Service Bulletin

Bulletin No. 033

Issue Date: July 10, 2008

ES7024-11 (TCM P/N 656872) ES7024-14 (TCM P/N 657199) ALTERNATOR FAN AND PULLEY REPLACEMENT

Figure 1 - Alternator Part Replacement

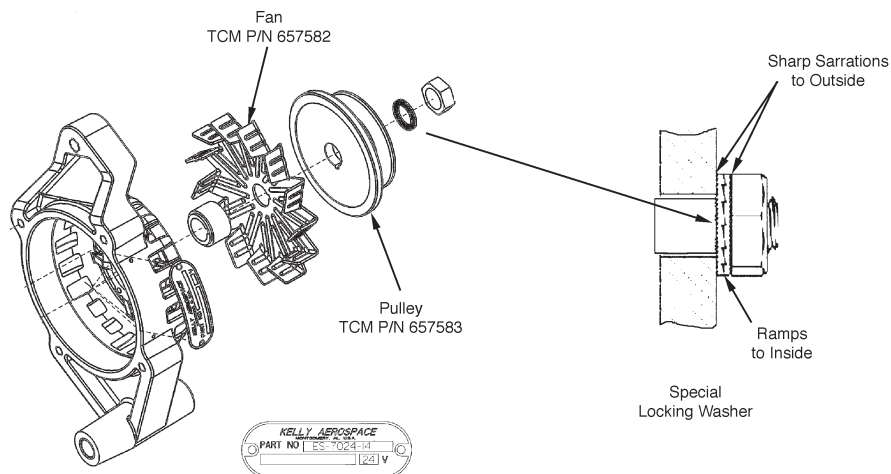
This Service Bulletin is being issued to mandate the replacement of both the fan and pulley assemblies on the existing ES7024(-11 & -14) alternators and to announce the availability of an improved pulley assembly which when installed will remedy the above condition.

5. Install a new TCM P/N 657582 fan, and new TCM P/N 657583 pulley as shown in Figure 1. Use the existing pulley nut and the locking washer. Take care when removing the locking washer as it is a special device which has two pieces. The sharp serrations must face outward while the shallow ramp must face each other. Using the strap wrench per instruction 4 above, torque the pulley nut to 35 to 45 ft-lbs.
